Project	<b>IEEE 802.16 Broadband Wireless Access Working Group</b> < <a href="http://ieee802.org/16">http://ieee802.org/16</a> >	
Title	<b>Sleep Mode in MR network</b>	
Date Submitted	<b>2007-01-16</b>	
Source(s)	Yuefeng Zhou; Mike Hart; Sunil Vadgama Fujitsu Laboratories of Europe Ltd Hayes Park Central, Hayes End Road, Hayes, Middlesex, UB4 8FE, UK	Voice: +44 (0) 20 8573 4444 FAX: +44 (0) 20 8606 4539 Email: <a href="mailto:Yuefeng.zhou@uk.fujitsu.com">Yuefeng.zhou@uk.fujitsu.com</a> <a href="mailto:Mike.hart@uk.fujitsu.com">Mike.hart@uk.fujitsu.com</a> <a href="mailto:Sunil.vadgama@uk.fujitsu.com">Sunil.vadgama@uk.fujitsu.com</a>
	Keiichi Nakatsugawa, Masato Okuda Fujitsu Laboratories Ltd. Kamikodanaka 4-1-1, Kawasaki, 211-8588, Japan	Voice: +81-44-754-2811 Fax: +81-44-754-2786 <a href="mailto:nakatsugawa@jp.fujitsu.com">nakatsugawa@jp.fujitsu.com</a> <a href="mailto:okuda@jp.fujitsu.com">okuda@jp.fujitsu.com</a>

## MS Sleep Mode in MR network

Figure XX – MR-BS approves of CIDs entering sleep mode

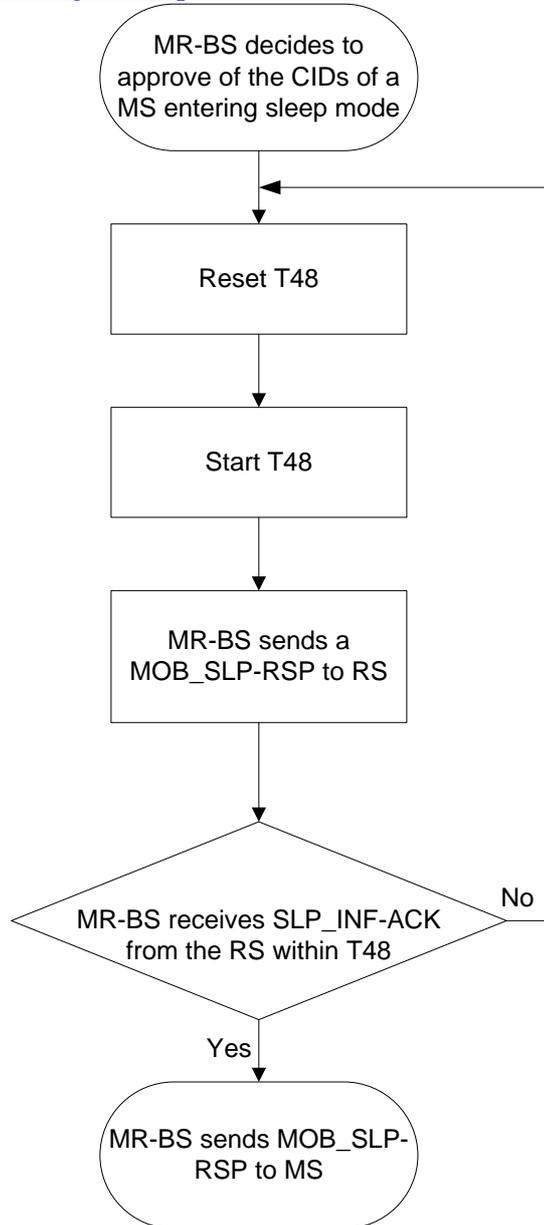
In the distributed scheduling case, the MR-BS shall firstly send a MOB\_SLP-RSP message to the RS on the RS’s basic CID. After receive this MOB\_SLP-RSP message, the RS shall send SLP\_INF-ACK

message to MR-BS to acknowledge that it got the information about the sleep context of the CIDs indicated. The MR-BS shall retransmit the duplicated MOB\_SLP-RSP message to the RS on the RS's basic CID, if it does not receive the SLP\_INF-ACK message from the corresponding RS within the T48 timer. Once MR-BS receives the SLP\_INF-ACK message, it shall send a MOB\_SLP-RSP message, which will be relayed by RSs, either in response to a MOB\_SLP-REQ or unsolicited. Fig. XX illustrates the procedure of MR-BS approving of sleep-mode CIDs.
